TT8009EN, Rev. A
September, 2017
Page 1 of 4

SUBJECT: Incorrect Engine Governed Speed Calibration Setting in Freightliner Custom Chassis Corporation (FCCC) Motorhomes

MODELS AFFECTED: 2500MH Transmissions in FCCC Motorhomes

Figure 1. Calibration Information Tab

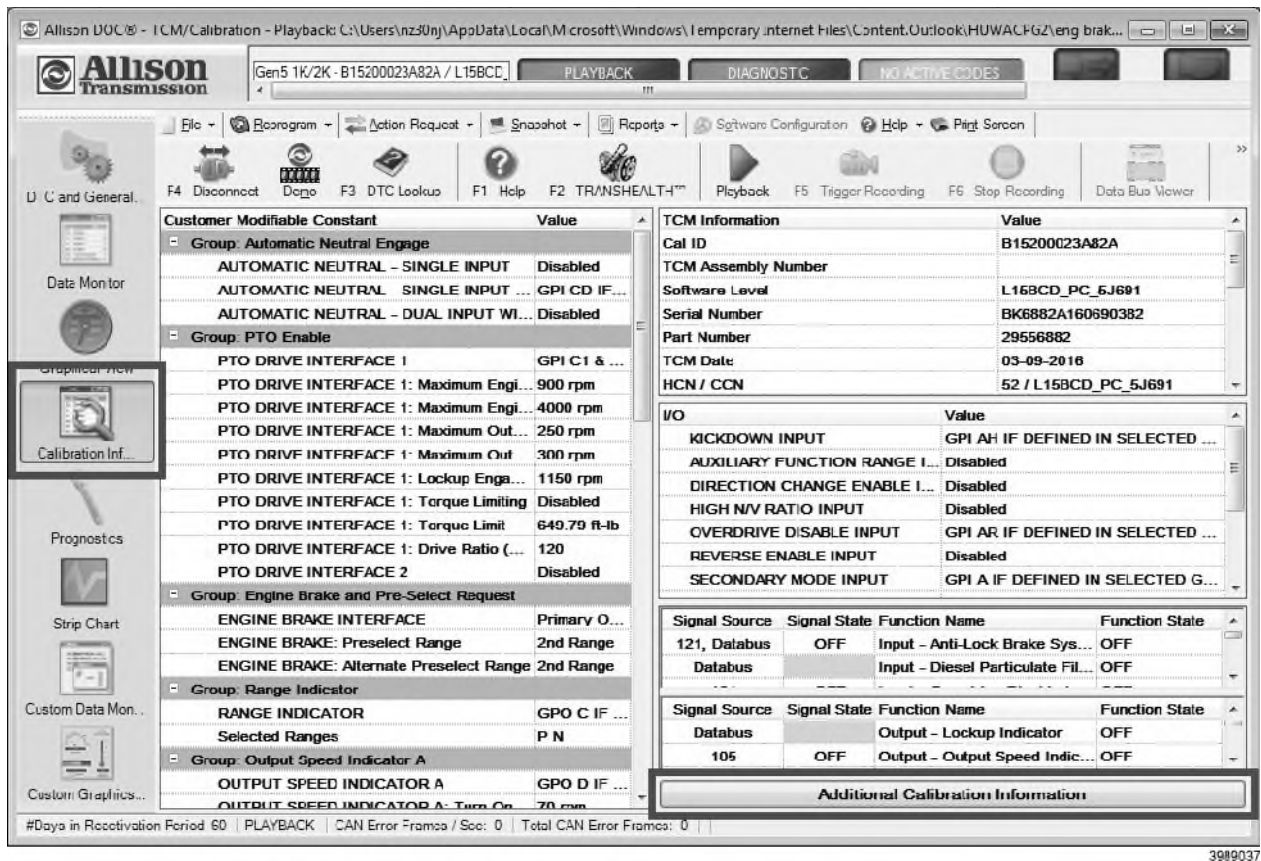
After reflashing the TCM, the technician should connect to the TCM using the Allison DOC® tool and look at the “Additional Calibration Information” located on the “Calibration Information” tab to verify that the following calibration parameters are set accordingly:

- Engine Governed Speed = 2600 rpm
- Primary Mode: Shift Speed = 2600 rpm
- Secondary Mode Shift Speed = 2200 rpm
